600-82822-BASE-700

K-Tigs USB BOARD

BOARD-TO-BOARD CONNECTOR

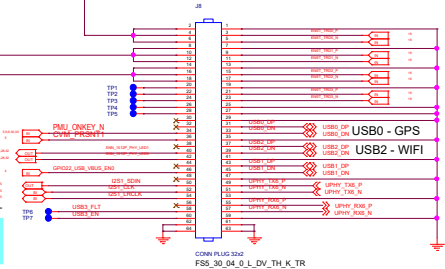
20/8 Added TP for 5 pins
26/8 Added TP on USB FLT/EN

Verify footprint - so pin 1 is not connecting pin 2 on other side !!!

I2S MICROPHONE

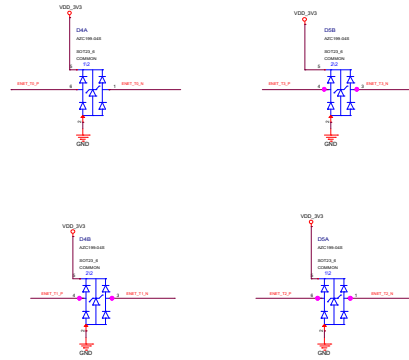
9/7 Igor asked to use other mic, and place with camera
11/7 Agreed on ICS-43434 from TDK
11/8 Added DR on Vdd/Gnd for debug options. (There are DR on signals in CVM page)
20/8 Added series resistors on I2S lines

```
replaced capacitors with 100V rated (0603)
in swapt D4 D5
```

USB3 Hub

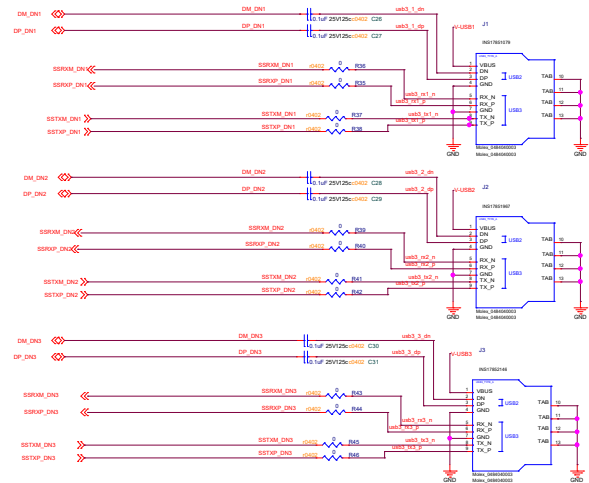
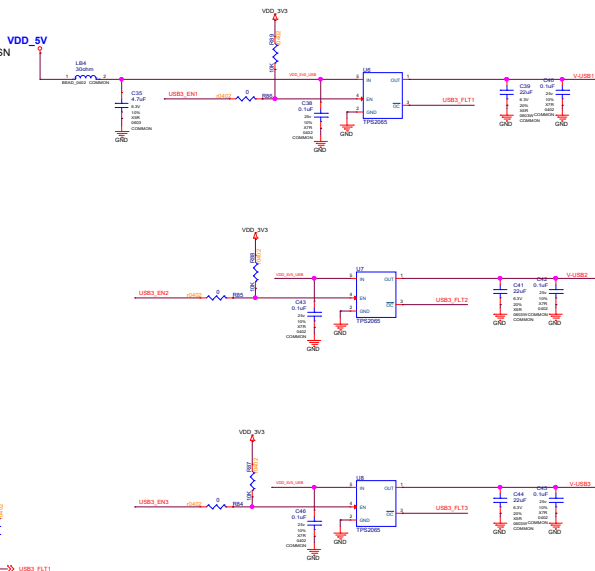
- 29/7 Removed FB from connectors - as in new RefDSN
- 4/8 ADD FB to supply - to isolate from other lines
- 4/8 ADD Power switches
- 5/8 Connected ESD (Added 3)
- 14/8 Changed pin, changed symbol - only 2 shields
- 3/9 Swap diodes per layout

USB3 Hub

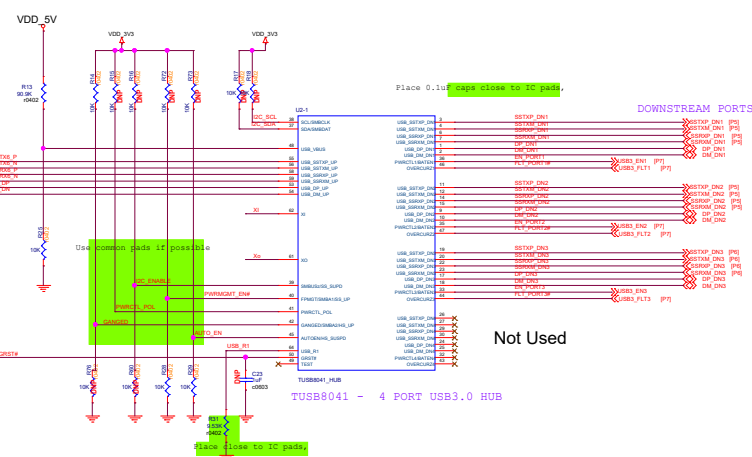
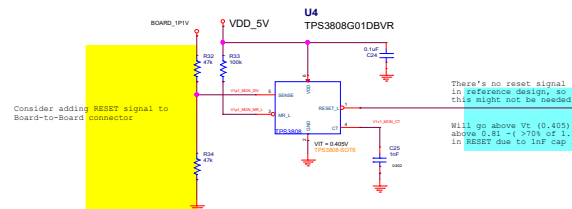
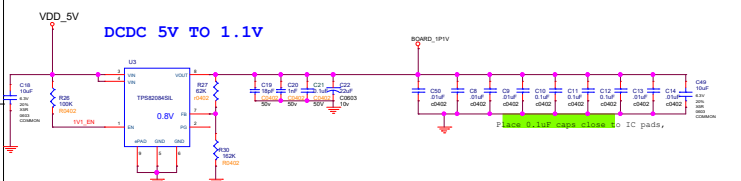
4/8 ADD FB to 3.3V supply - to isolate from other lines
20/8 Removed duplicate PU on EN. Clean-up: moved items etc.

Consider adding option for 24MHz oscillator, 1.8v, 50ppm, <50ps p-p jitter

There's no reset signal in reference design, so this might not be needed

Will go above V_t (0.405) when power is above 0.81 - (>70% of 1.1.), and will keep in RESET due to 1nF cap in CT.

USB - WiFi & GPS

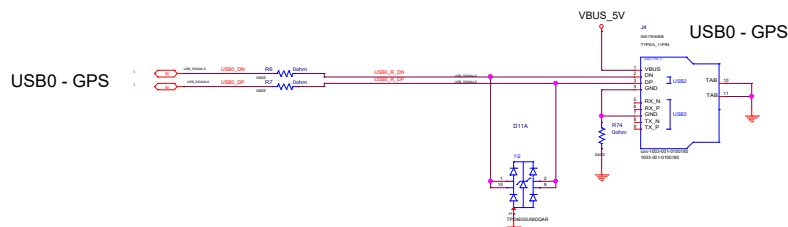
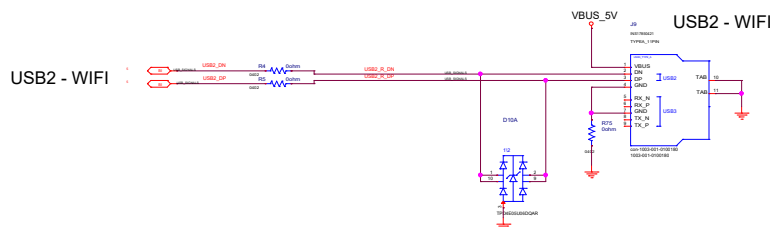
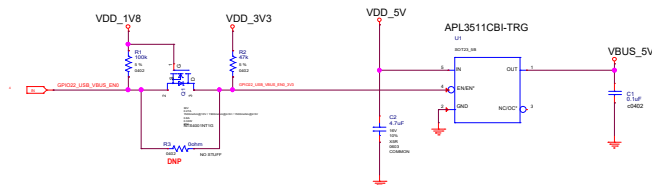
- 30/7 Assigned GPIO to Vbus-enable
- 30/7 Defined B2B connectors
- 31/7 Replaced ESD on USB2
- 12/8 Removed CM Chock
- 13/8 Changed FB on connectors (GND) to 0R (per P2597-c02)
- 20/8 Changed ESD to have 2 separate
